**Re: Scoping Document on Once Through Cooling**

**Water Quality Control Policy on the  
Use of Coastal and Estuarine Waters for Power Plant Cooling**

**PG&E Comments on**  
**California Coastal Power Plants**  
**Cost and Engineering Analysis of Cooling System Retrofits**  
**Draft Prepared by Tetra Tech**

## **2. COMMENTS ON CHAPTER 7C — DIABLO CANYON POWER PLANT**

Figure C-6. Cooling Tower Locations

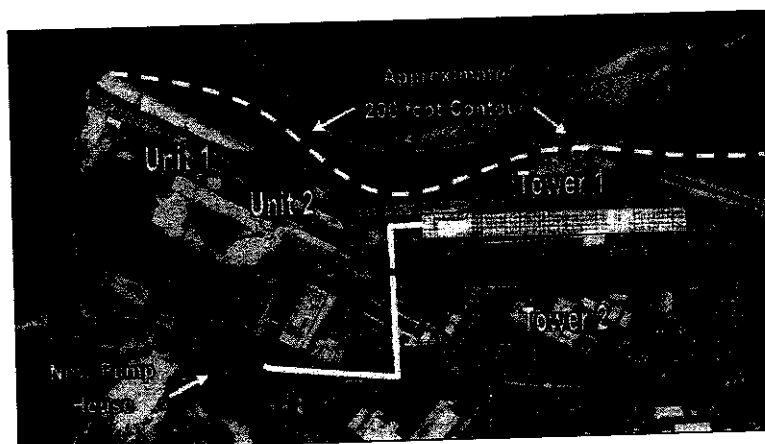
The location of the new Pump House as shown in Figure C-6 blocks access to the Turbine Building crane bay where all large pieces of machinery (turbine rotors, generators, pumps, etc) enter and exit the building. Its proposed location is technically unacceptable.

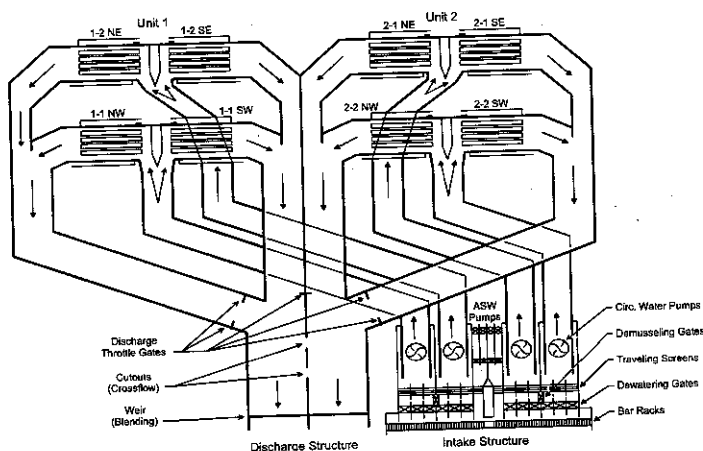
The following schematic shows the existing circulating water conduits to the condenser. Connections would have to be made to all the supply and return conduits including those coming from the north end of the Unit 1 condenser. A review of detailed site drawings indicates that the excavations and routing required for these large-diameter connections would be an extremely difficult, if not impossible, engineering task.

The limited area for this inter-tie in front of the turbine building is extremely congested with both safety-related and non-safety-related systems, piping and conduits.
